WILLIAMSON COUNTY, TEXAS CHANGE ORDER NUMBER: 1

CR 110 Middle Williamson County Project No. 1809-261

Change Order No. 1

QUANTITY SUMMARIES

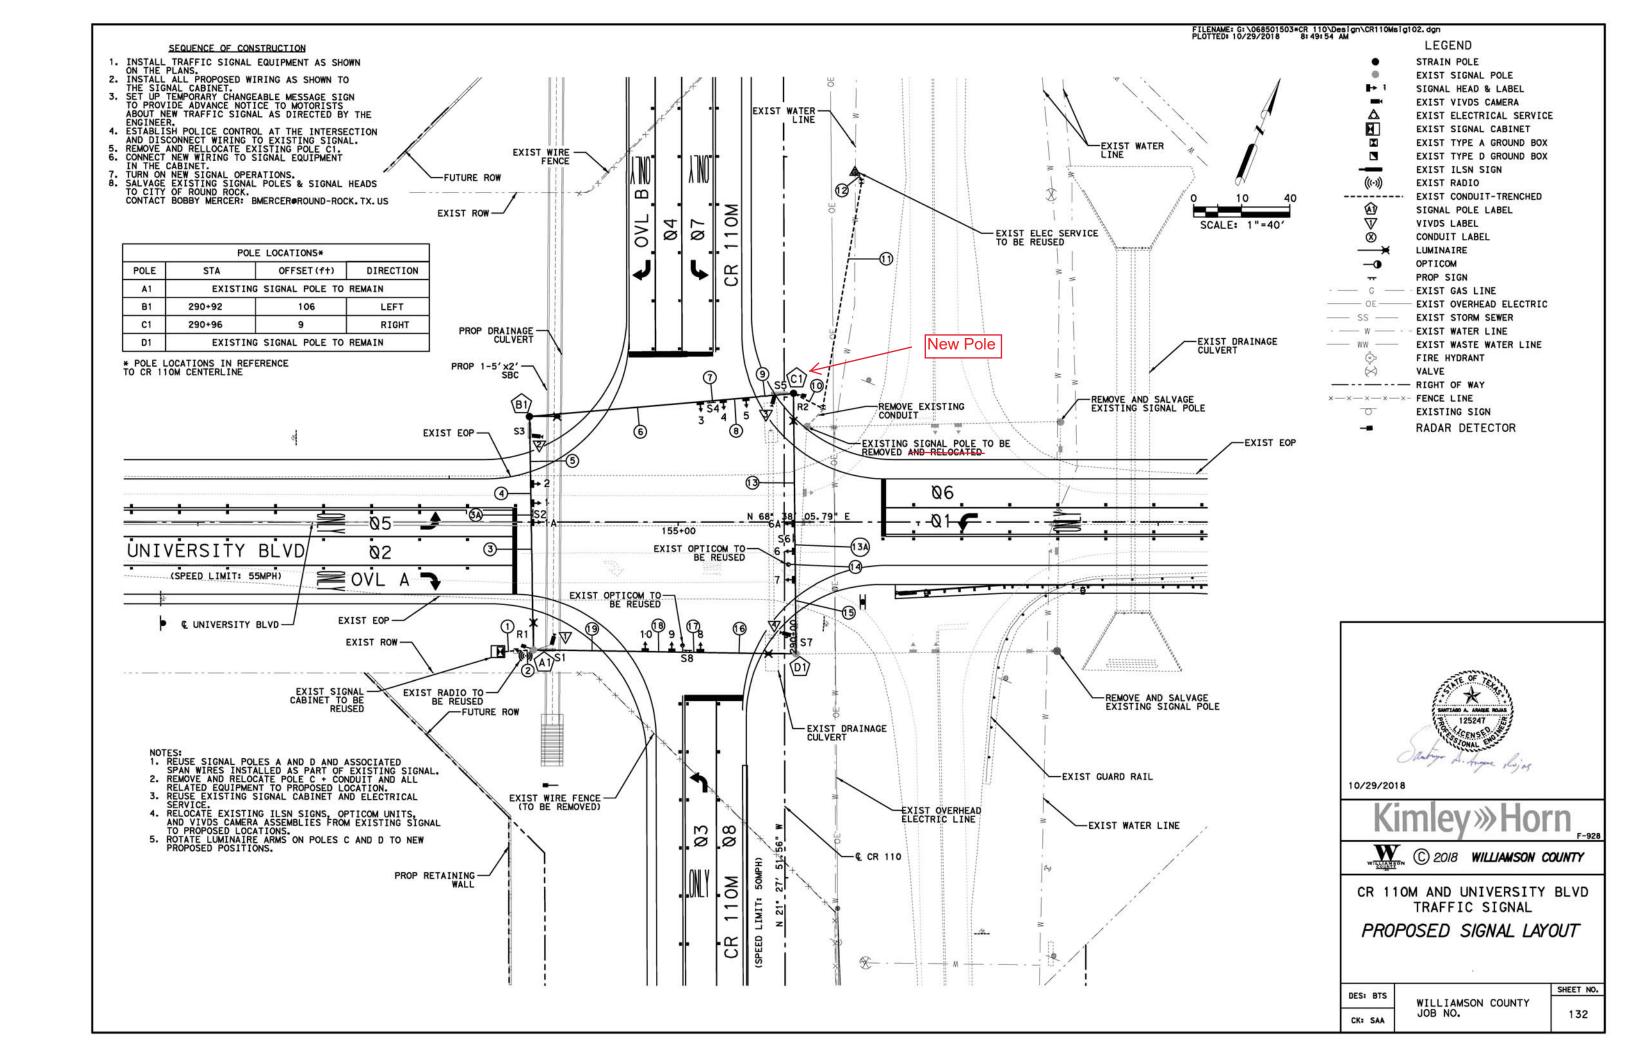
ADJUSTED SIGNAL FOUNDATION QTY
ADDITIONAL ILSN

ADJUSTED SIGNAL FOUNDATION QTY

SHEET NO. 137G

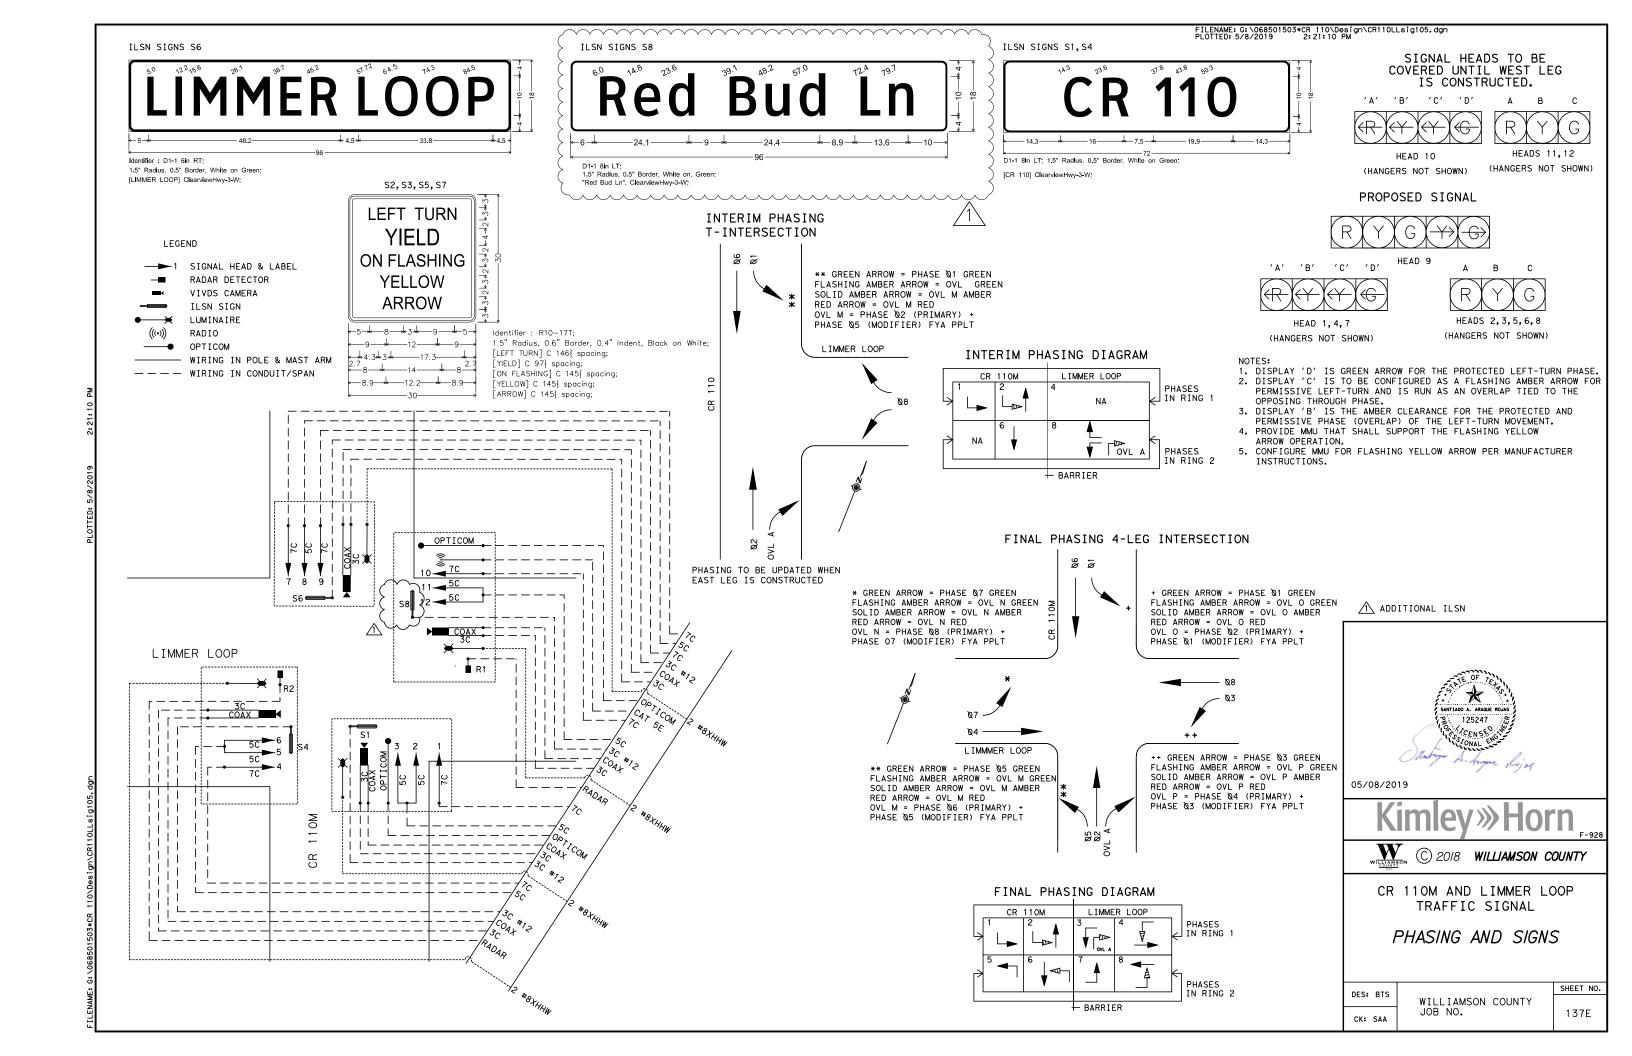
ADJUSTED SIGNAL FOUNDATION QTY ADJUSTED ILSN SIGN QUANTITY
